Issue	**1**
Factory ID	**26310**
Date of Issue	**19-May-2026**

A A Garments

Fire Safety Inspection Report

Pakistan Accord Initial Safety Inspection Report

Figure 2.16 - Basement is not fire separated from the rest of the building at Main Building.

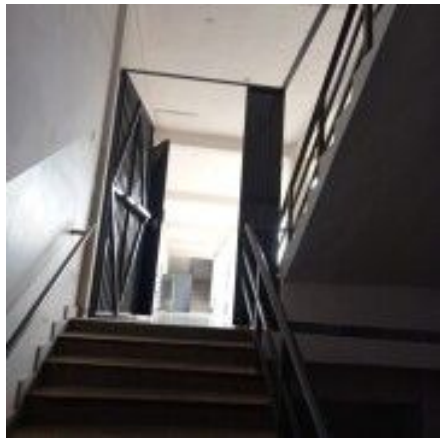
The following deficiencies have been observed on site, including (list not exhaustive):
- Basement is not fire separated from the rest of the building at Main Building.

Timeline	Remediation Plan
Medium Term CAP-0076072	Prepare a plan and drawings showing the proposed separation details. These shall be submitted to Pakistan Accord for review and approval prior to the rectification works. The drawings should cover: - Different occupancy types in the building - Proposed fire separation details (including fire rating of walls and doors)
Longer Term CAP-0076073	Provide fire rated separation between occupancies as per proposal reviewed by Pakistan Accord
